# SITE PLAN REVIEW AND APPEARANCE BOARD ---STAFF REPORT---CITY OF DELRAY BEACH

December 16, 2015

Martini Property - Class V Site Plan and Landscape Plan With The

Construction Of A Driveway and Parking at 59 SE 4th Avenue.

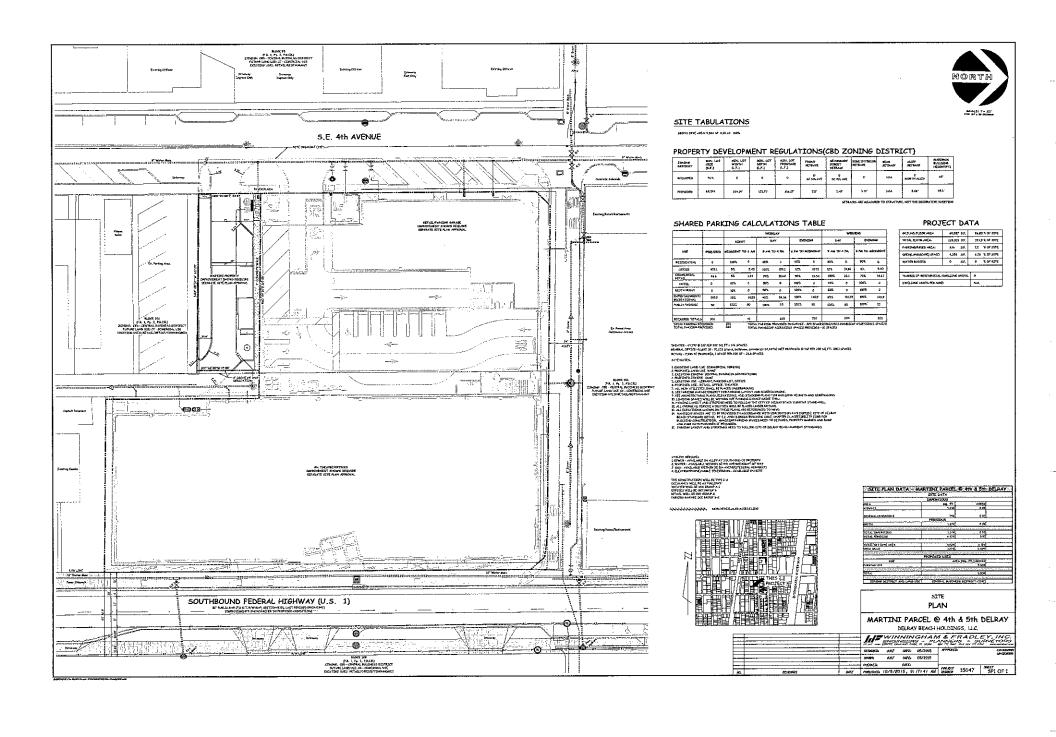
1. Tree #'s 1 -3 (city-owned Foxtail Palms) and #'s 6-7 (Sabal Palms) shall be saved either on-site or off-site. Update the Existing Tree Disposition plan to show final locations for all relocated trees. Provide a separate column entitled "Relocated To". Trees will either be relocated on-site or off-site. If off-site, provide an asterisk next to each tree with a note. The note shall read, "All trees to be relocated off-site shall be coordinated with the City of Delray

Beach a minimum of six (6) weeks prior to relocation. Call Peter Anuar, Senior Landscape Planner, at (561) 243-7226 for coordination."

- 2. Per LDR 4.6.16(H)(3)(d), a five foot (5') wide landscape buffer is required on the north side of the property. A two foot (2') hedge along with shade trees spaced no farther than thirty feet (30') on center is required within this buffer.
- 3. Per LDR 4.6.16(E)(5), all required trees are to be a minimum of sixteen feet (16') in height with a seven foot (7') spread and eight foot (8') of clear trunk. Revise specifications and species if this size cannot be found for the species that is currently being proposed.
- 4. Landscape Maintenance Agreement is required for the proposed plantings outside the property line. Submit the signed agreement with the supporting exhibits (as outlined in the agreement) as quickly as possible. This will need to be executed by City Commission.
